Bid Addendum #1

PROJECT: Johnston County Public Schools
Four Oaks Elementary School HVAC Renovation

CPL PROJECT NO.: R23.00325.00

DATE: March 7, 2025

Drawing Number: FOES H201.2

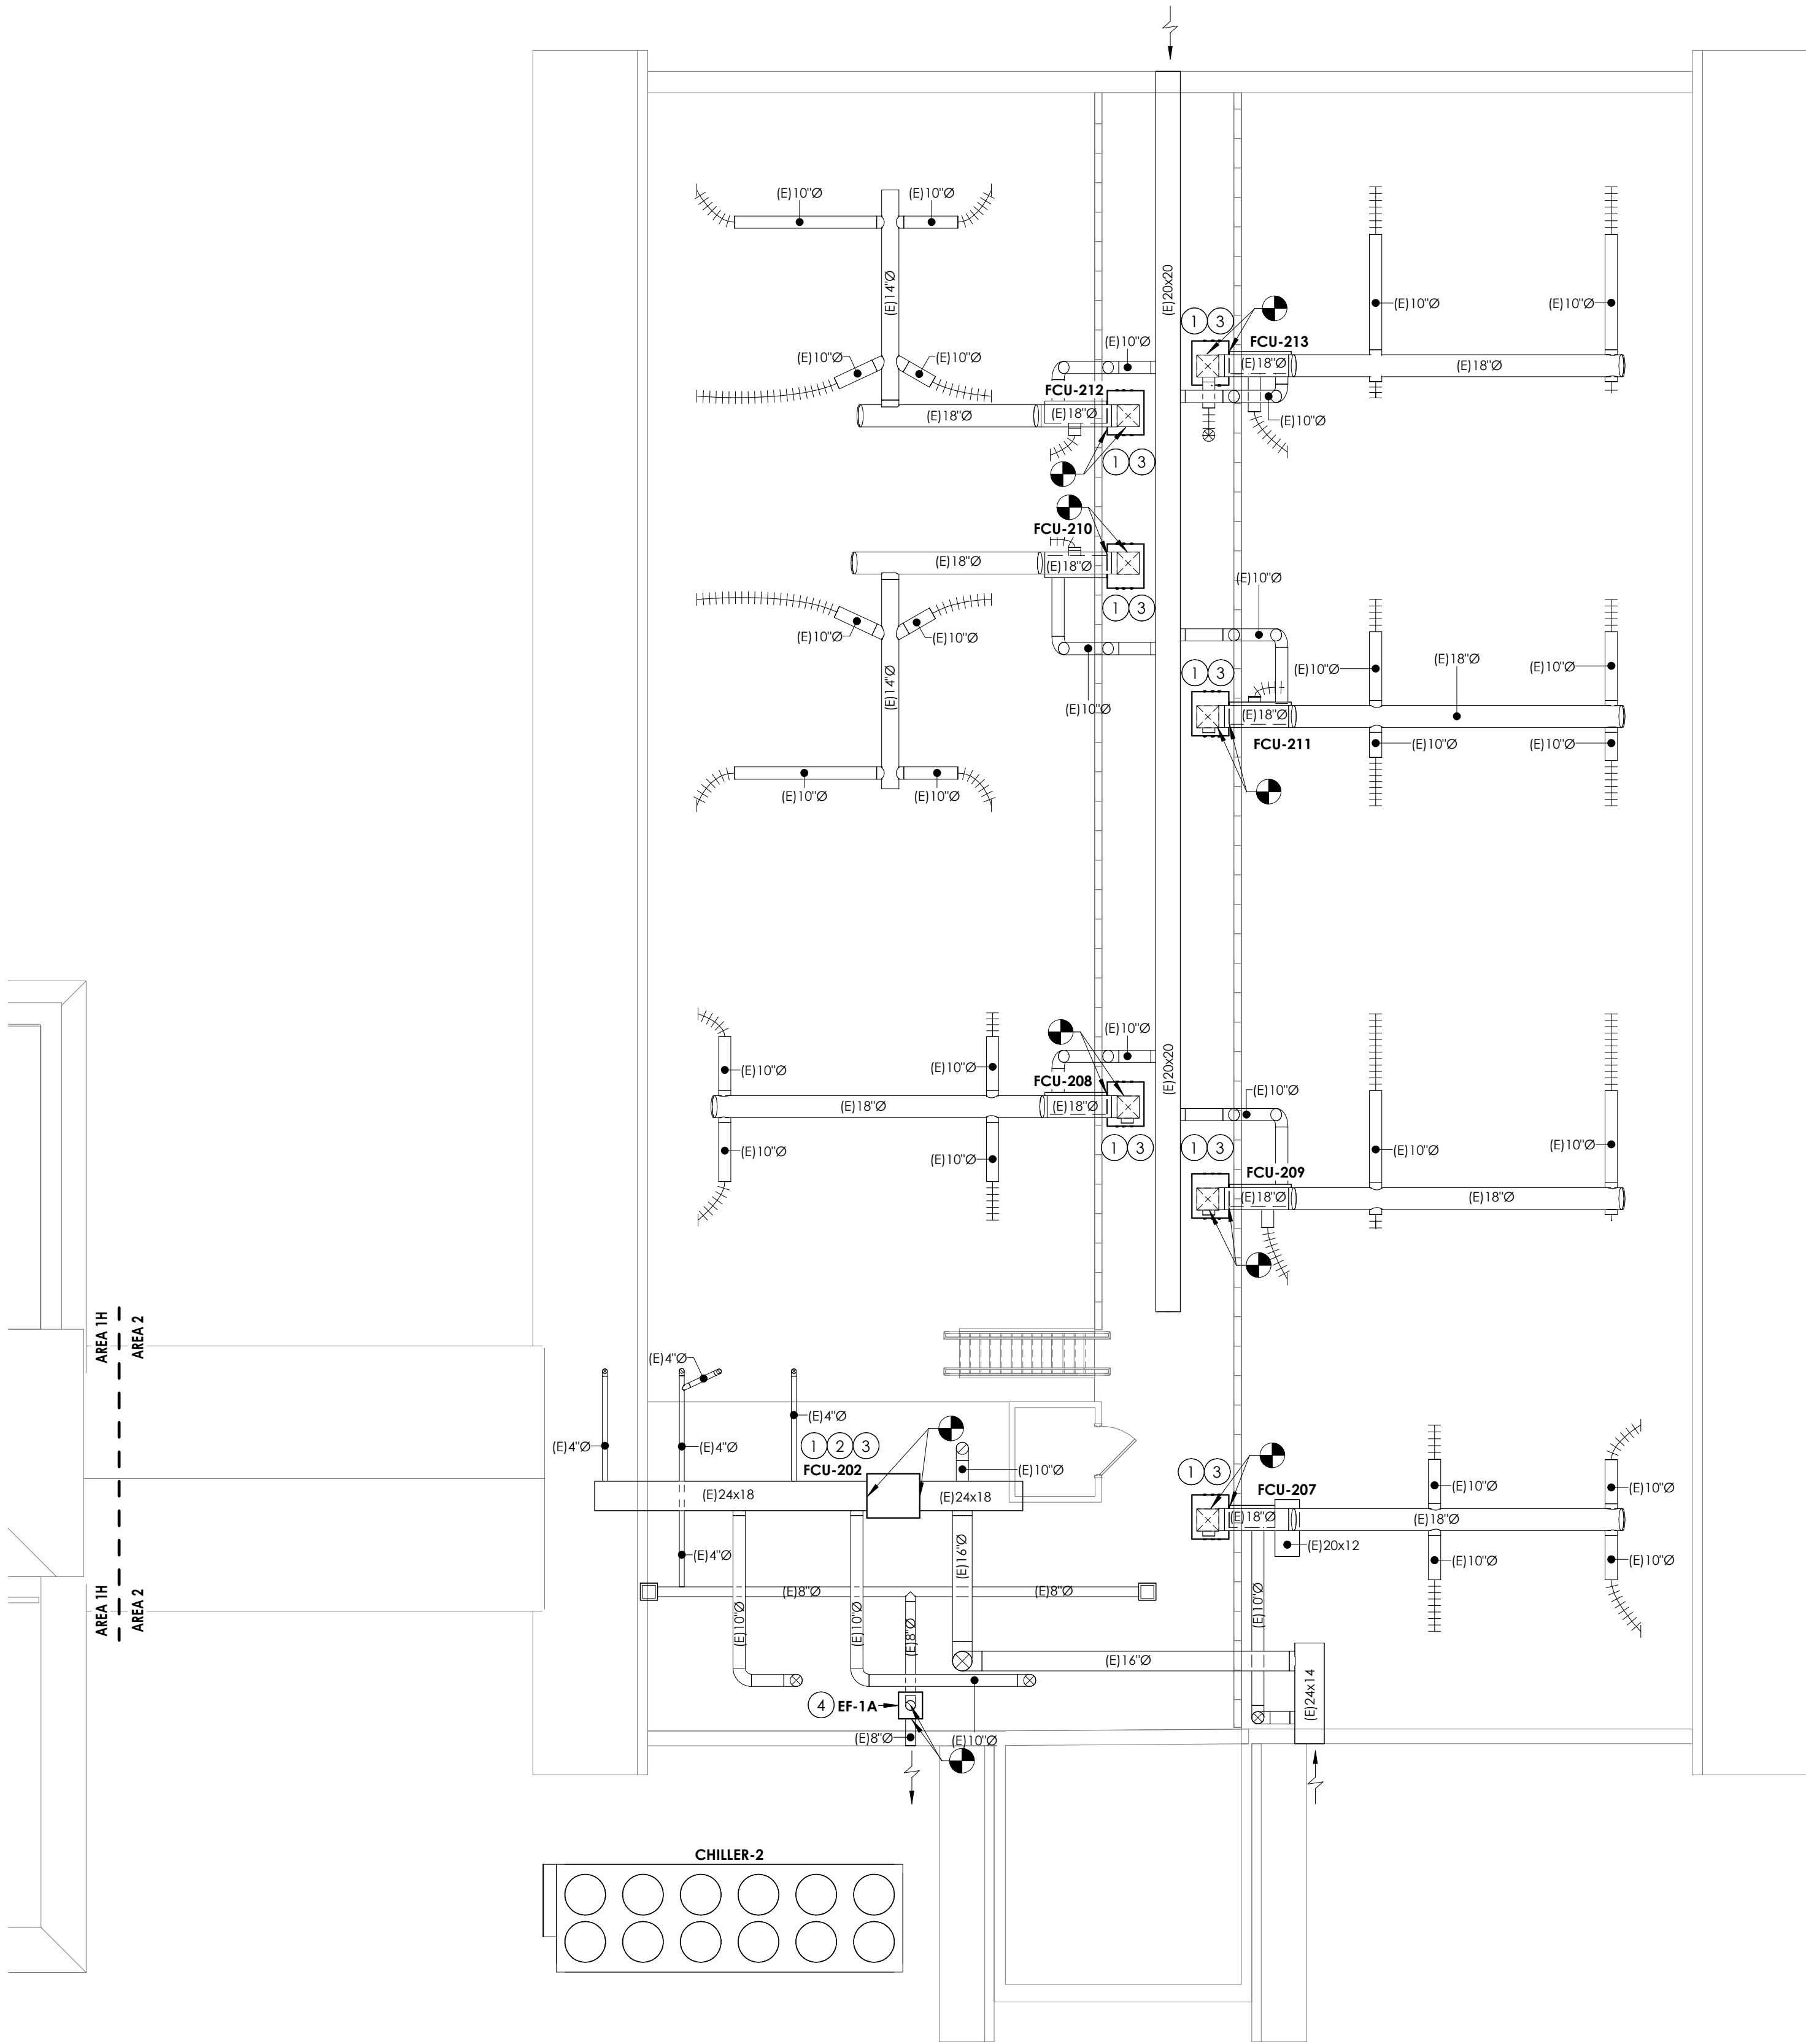
- ① PROVIDE INLINE EXHAUST FAN WITH ASSOCIATED DUCTWORK AND CONTROLS. EXTEND DUCT THROUGH WINDOW SPANDREL PANEL WITH LOUVER AND TERMINATE WITH BAROMETRIC BACKDRAFT DAMPER.
- ② PROVIDE NEW FAN COIL UNIT WITH ASSOCIATED DUCTWORK, PIPING, AND CONTROLS.

Drawing Number: FOES H301.2

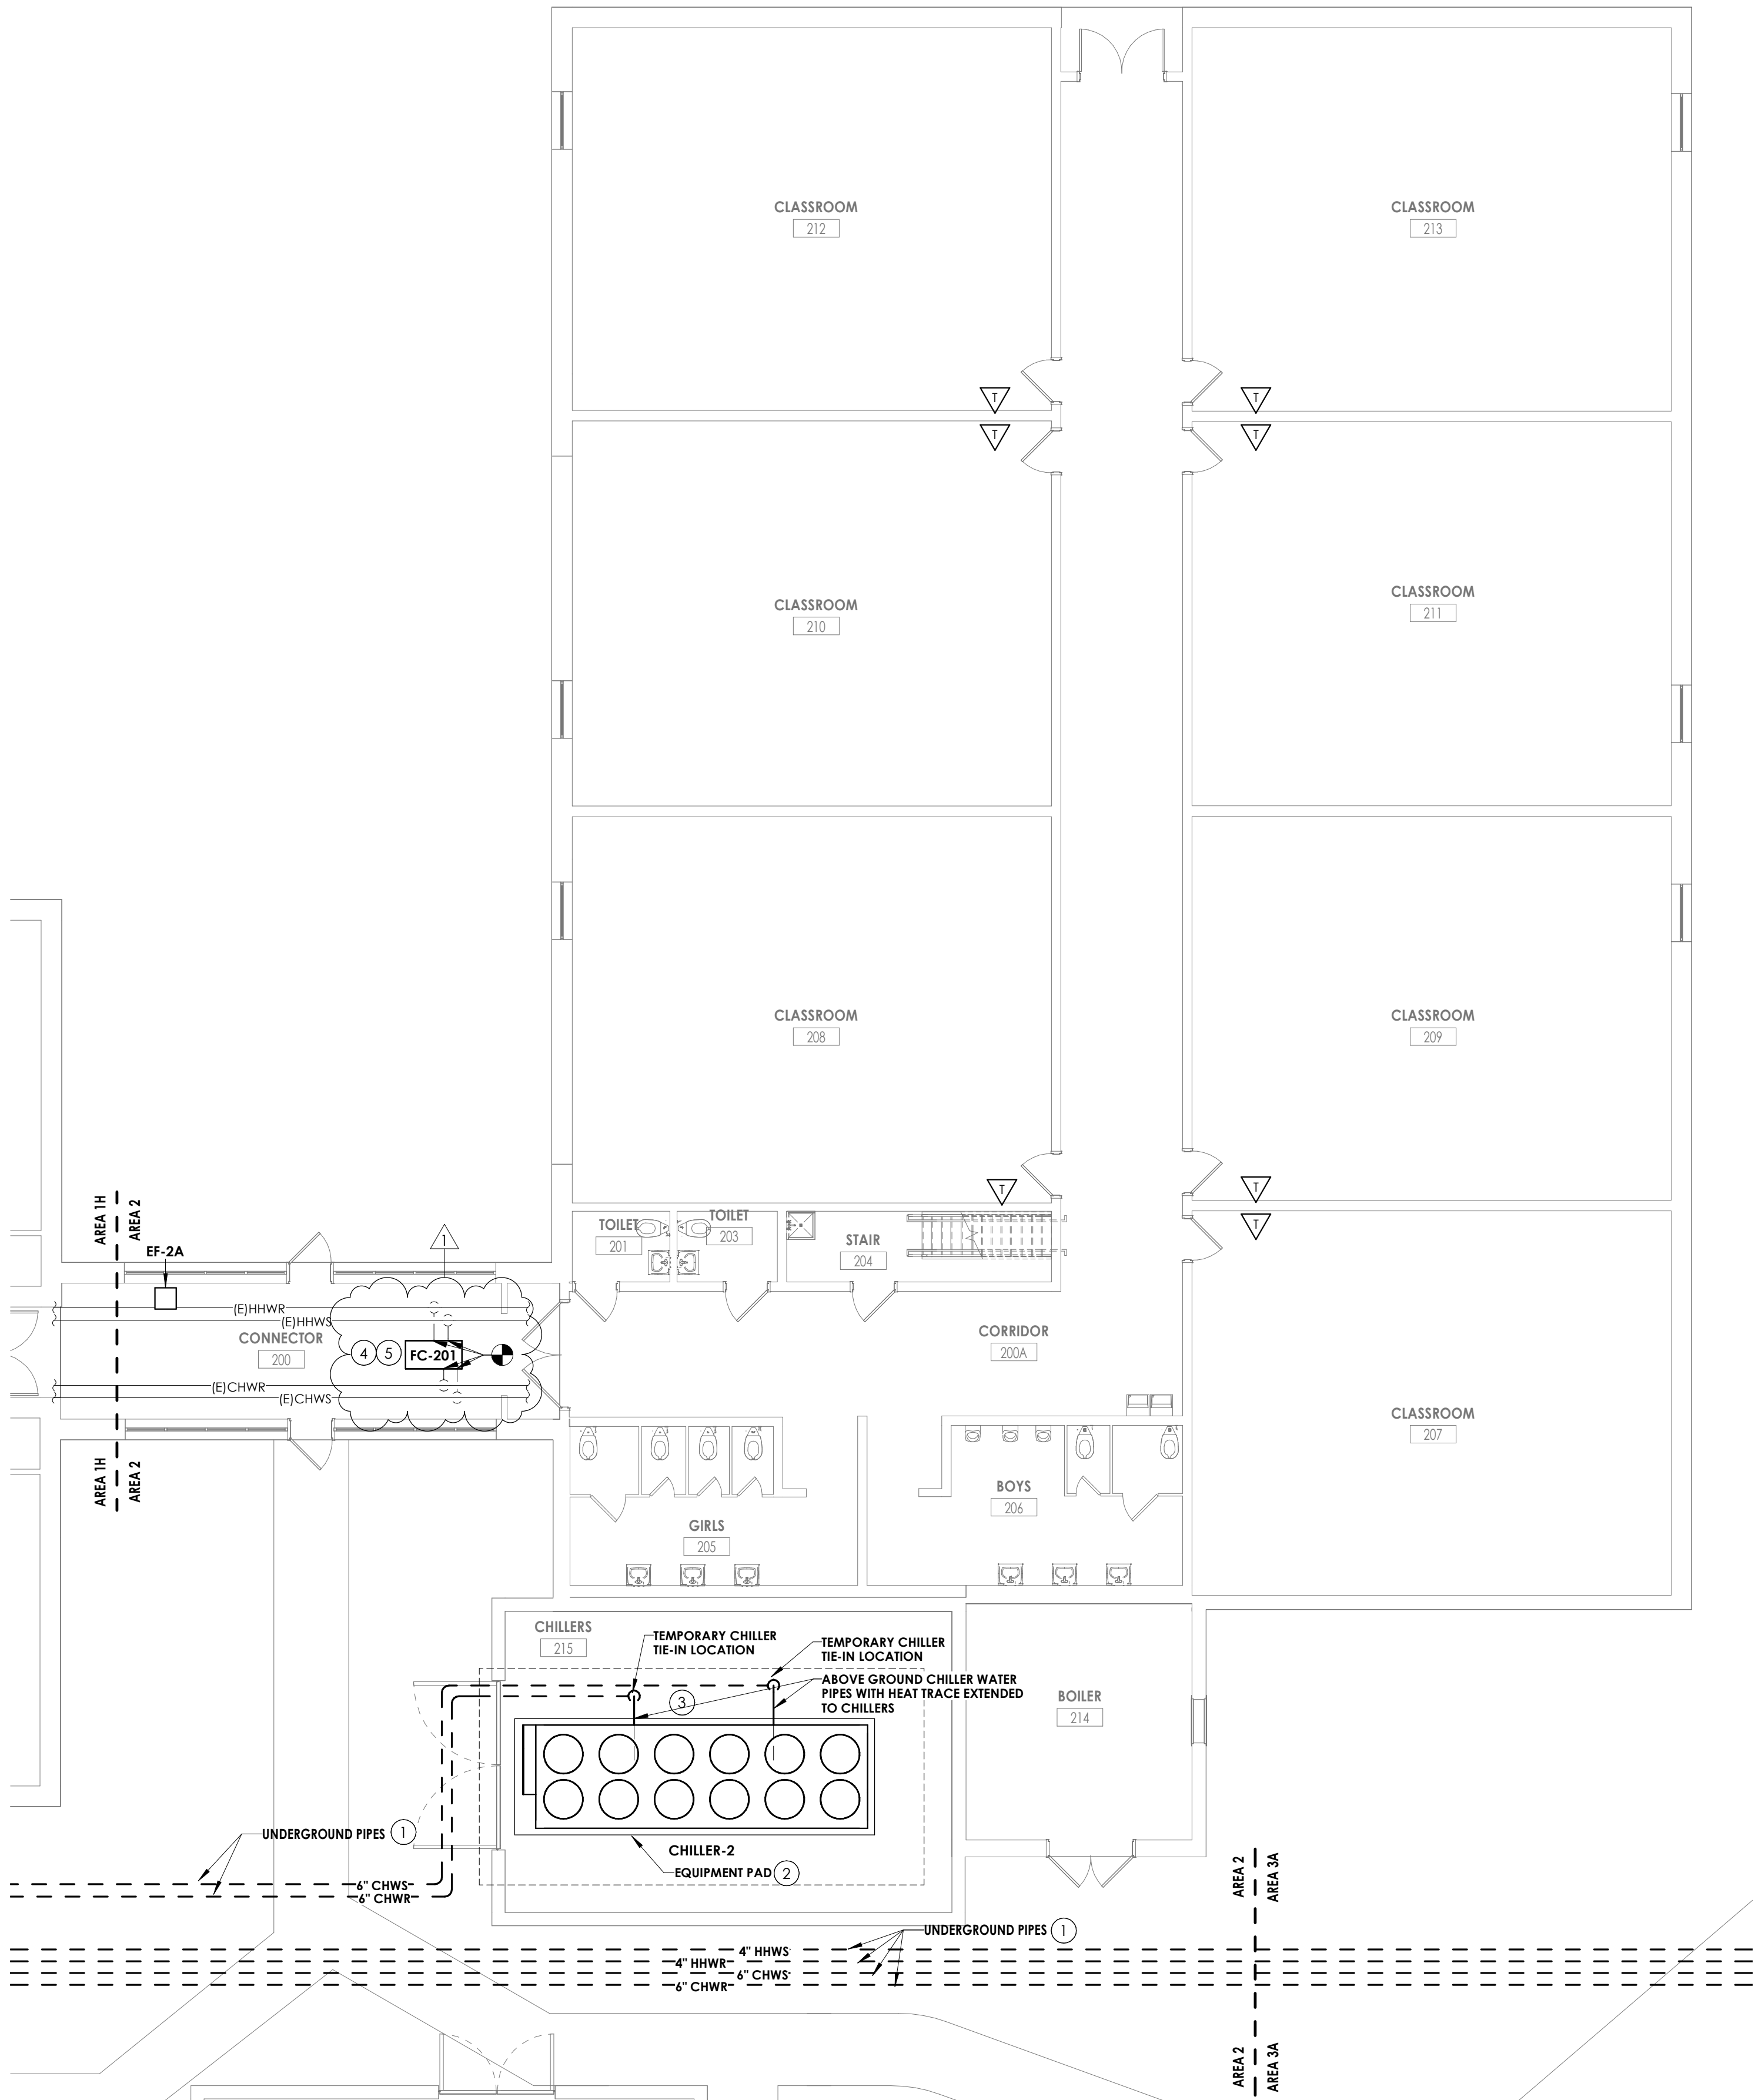
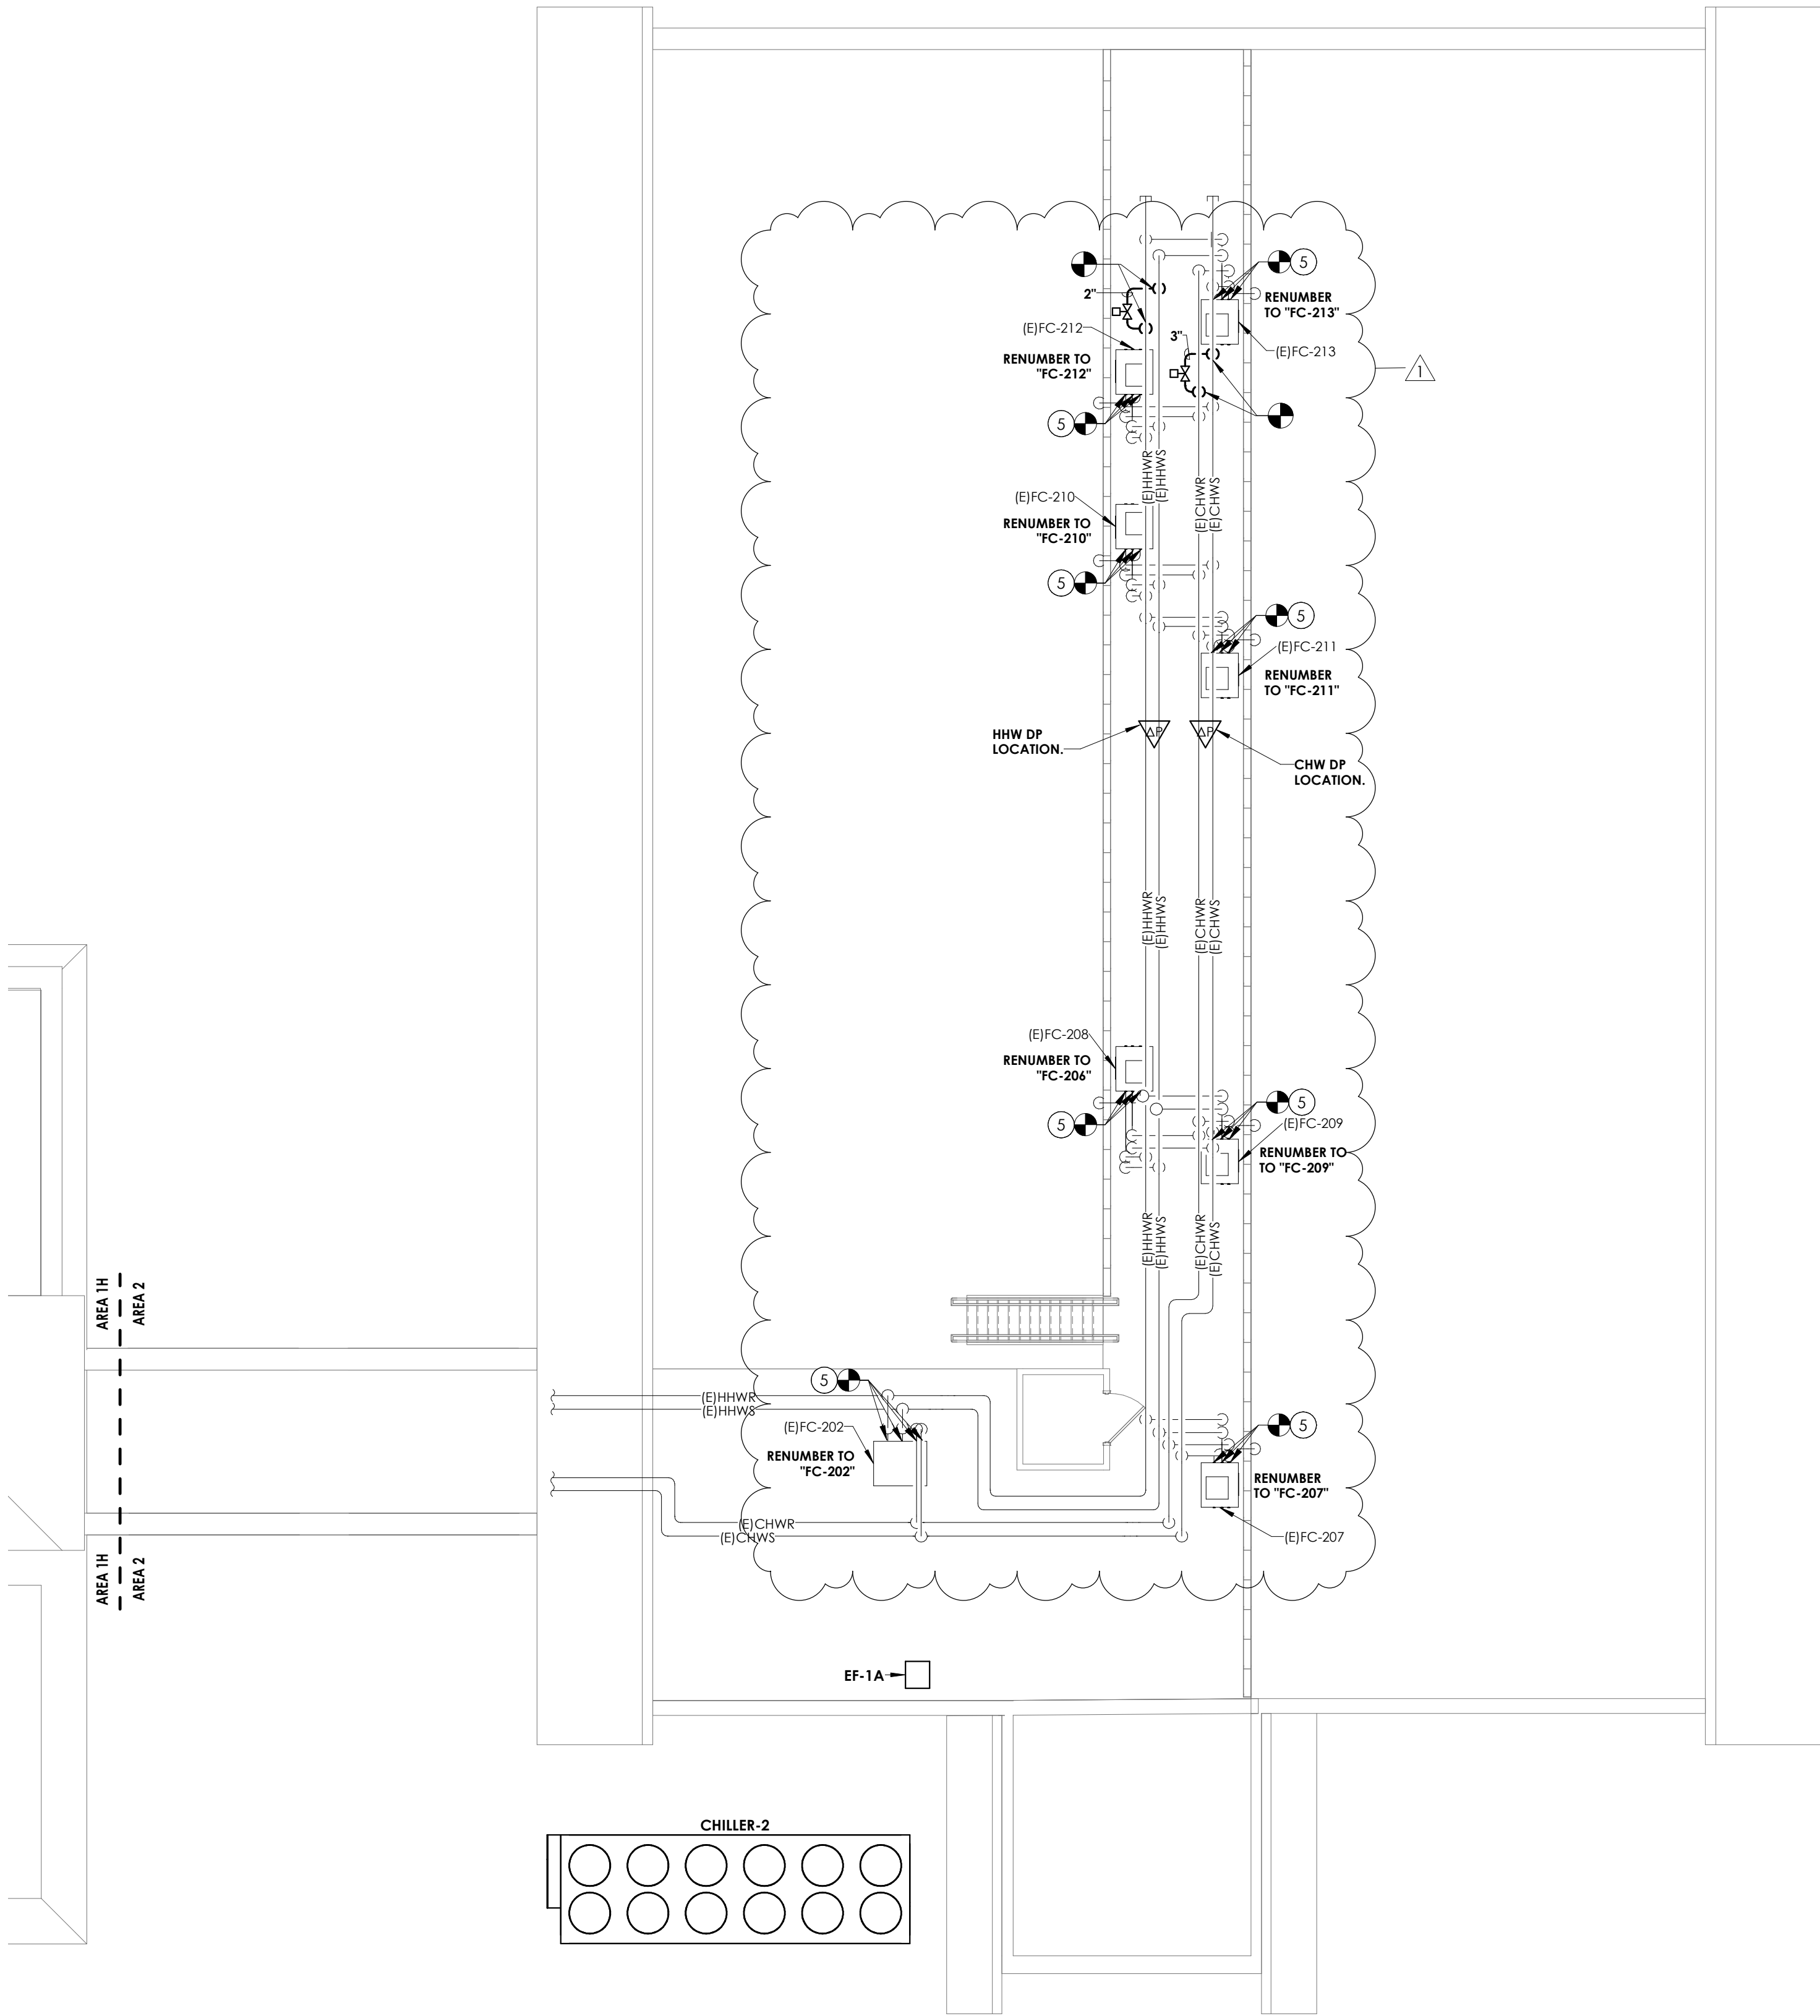
5 **ALTERNATE NO. 5:** REMOVE FAN COIL UNIT AND REPLACE WITH SIMILAR CARRIER MAKE AND MODEL WITH SAME HORSE POWER RATING AND POWER REQUIREMENTS. RECONNECT TO EXISTING PIPING AS CLOSE AS POSSIBLE.
